ZGAVG2 - 3-7/8" Air Vent Grommet Cap

SUBMITTAL IDENTIFICATION SHEET

WEBSTER UNIVERSITY ISB	
PROJECT NAME	
8274 BIG BEND BLVD	
ADDRESS	
NUMBER	
WEBSTER UNIVERSITY	
OWNER	
CANNON DESIGN	
ARCHITECT / ENGINEER	
DEVIN D GATES	
SUBMITTED BY	
123553-001 REV 2	
CONTRACTOR / CM SUBMITTAL NO.	CANNON DESIGN SUBMITTAL NO.
	123553
DRAWING / DETAIL REFERENCE	SPECIFICATION SECTION / PARAGRAPH
MANUFACTURER / SUPPLIER	ITEM / PRODUCT ID
REQUIRED DATE	PRIORITY
	CRITICAL

ZGAVG2 CAP

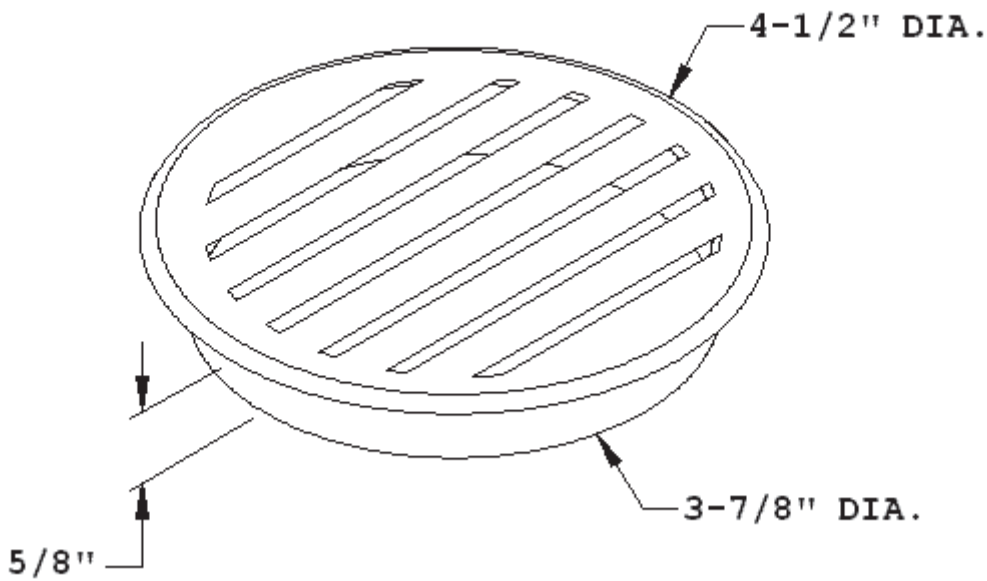
A/E SELECT COLOR

ADDED PER
ASI 35
DG
